SHEARON HARRIS NUCLEAR POWER PLANT
DOCKET NO. 50-400/LICENSE NO. NPF-63
STEAM GENERATOR REPLACEMENT
LICENSE AMENDMENT REQUEST
ERRATA SHEETS

ERRATA SHEETS FOR ENCLOSURE 6 TO HNP-00-142, DATED OCTOBER 4, 2000

ERRATA SHEETS FOR WCAP-15399 (Non-proprietary)

Figure 6.1.3-1 Post-LOCA Sump Boron Concentration

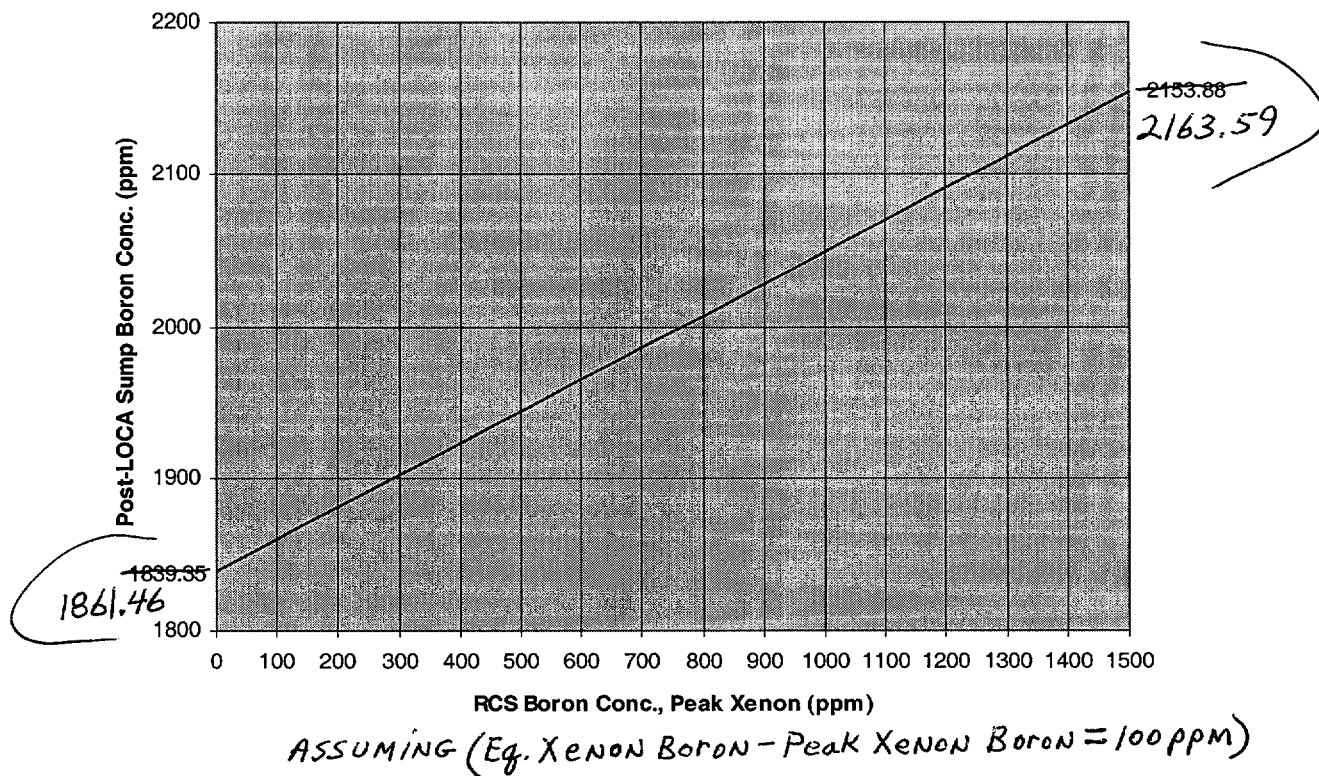
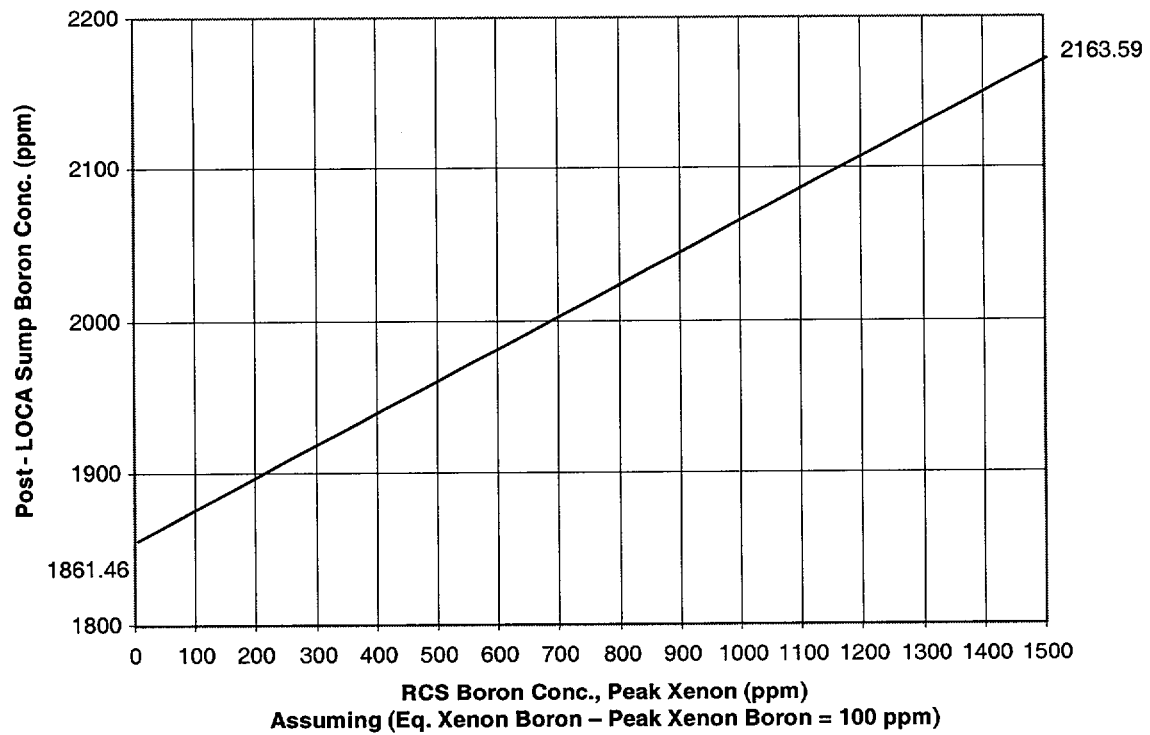
Mixed Mean Sump Boron Calculation: The results were tabulated for RCS boron concentration of 0 and 1500 ppm assuming the pre-trip RCS boron concentration for peak xenon concentration to be 100 ppm lower than the equilibrium xenon case. The straight-line curve (See Figure 6.1.3-1.) fit for the two points provided above is:

$$y = 0.20142x + 1839.35$$

1861.46

$$y = 0.20142x + 0.03653n + 1857.81$$

1835.542

Mixed Mean Sump Boron Calculation: The results were tabulated for RCS boron concentration of 0 and 1500 ppm assuming the pre-trip RCS boron concentration for peak xenon concentration to be 100 ppm lower than the equilibrium xenon case. The straight-line curve (See Figure 6.1.3-1.) fit for the two points provided above is:

$$y = 0.20142 x + 1861.46$$

$$y = 0.20142 x + 0.03653 n + 1857.81$$

Figure 6.1.3-1 Post-LOCA Sump Boron Concentration

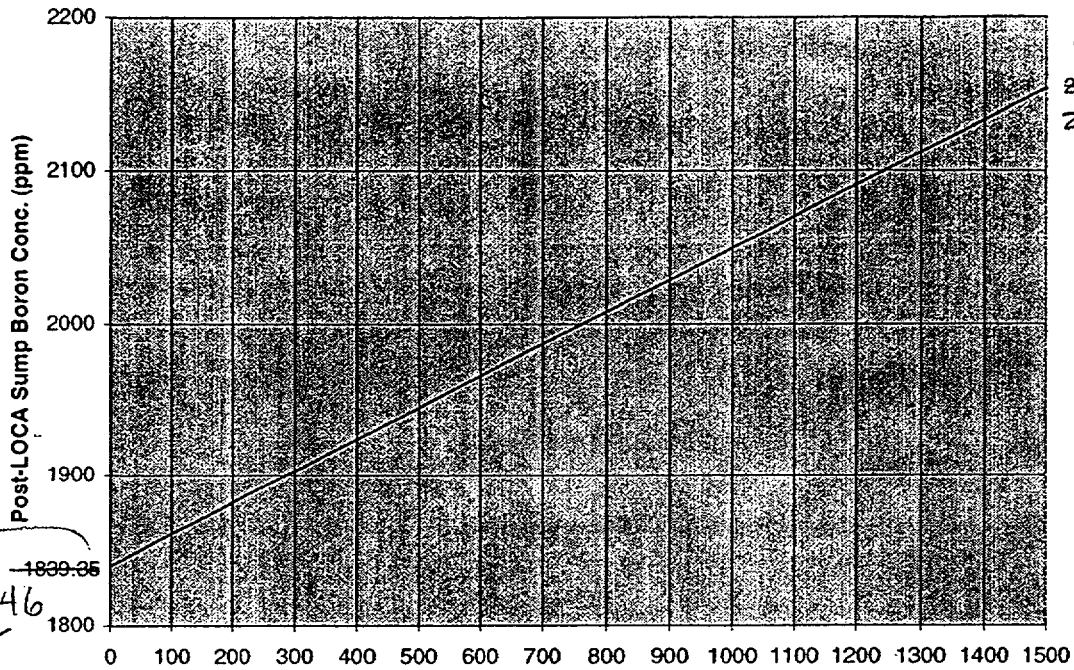
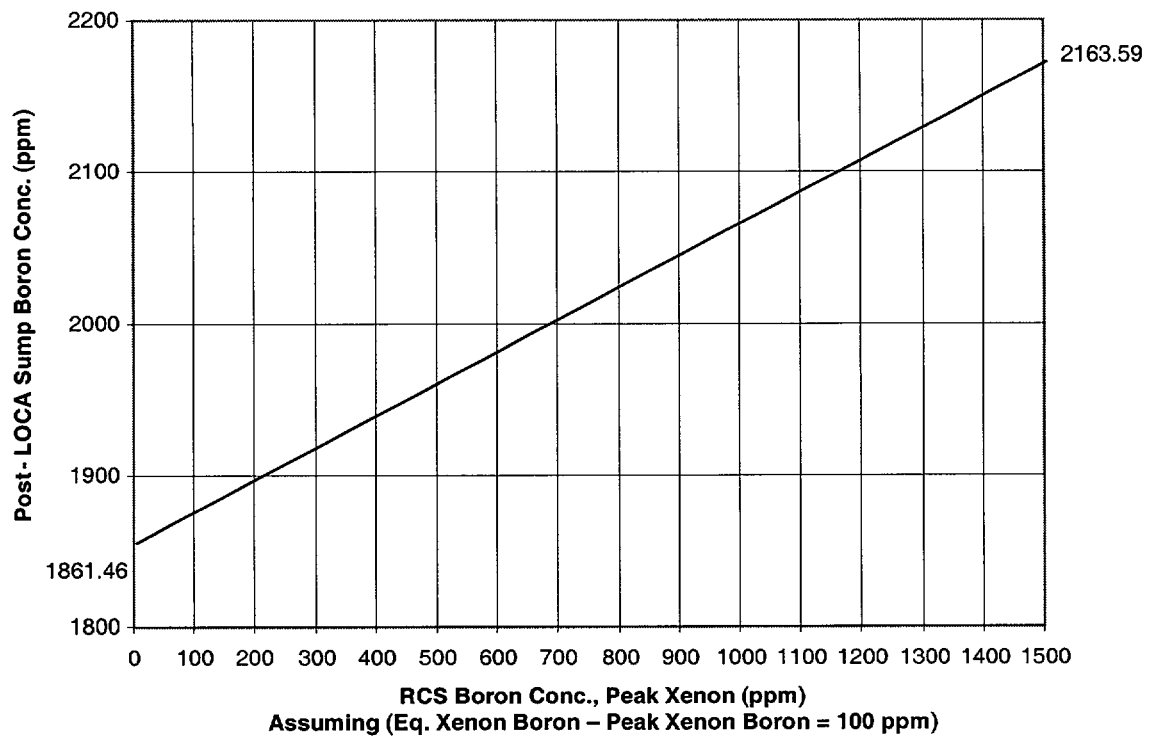
$$\begin{array}{r} 0.20142 \quad 1861.46 \\ y = 0.20969 x + 1839.35 \end{array}$$

An alternate equation is provided below where "n" is the difference in boron concentration between the peak and equilibrium xenon concentration case. (See Figure 6.1.3-1.)

$$\begin{array}{r} 0.20142 \quad 0.03653 \quad 1857.81 \\ y = 0.20969 x + 0.038036 n + 1835.542 \end{array}$$

$$y = 0.20142 x + 1861.46$$

An alternate equation is provided below where “n” is the difference in boron concentration between the peak and equilibrium xenon concentration case. (See Figure 6.1.3-1.)

$$y = 0.20142 x + 0.03653 n + 1857.81$$
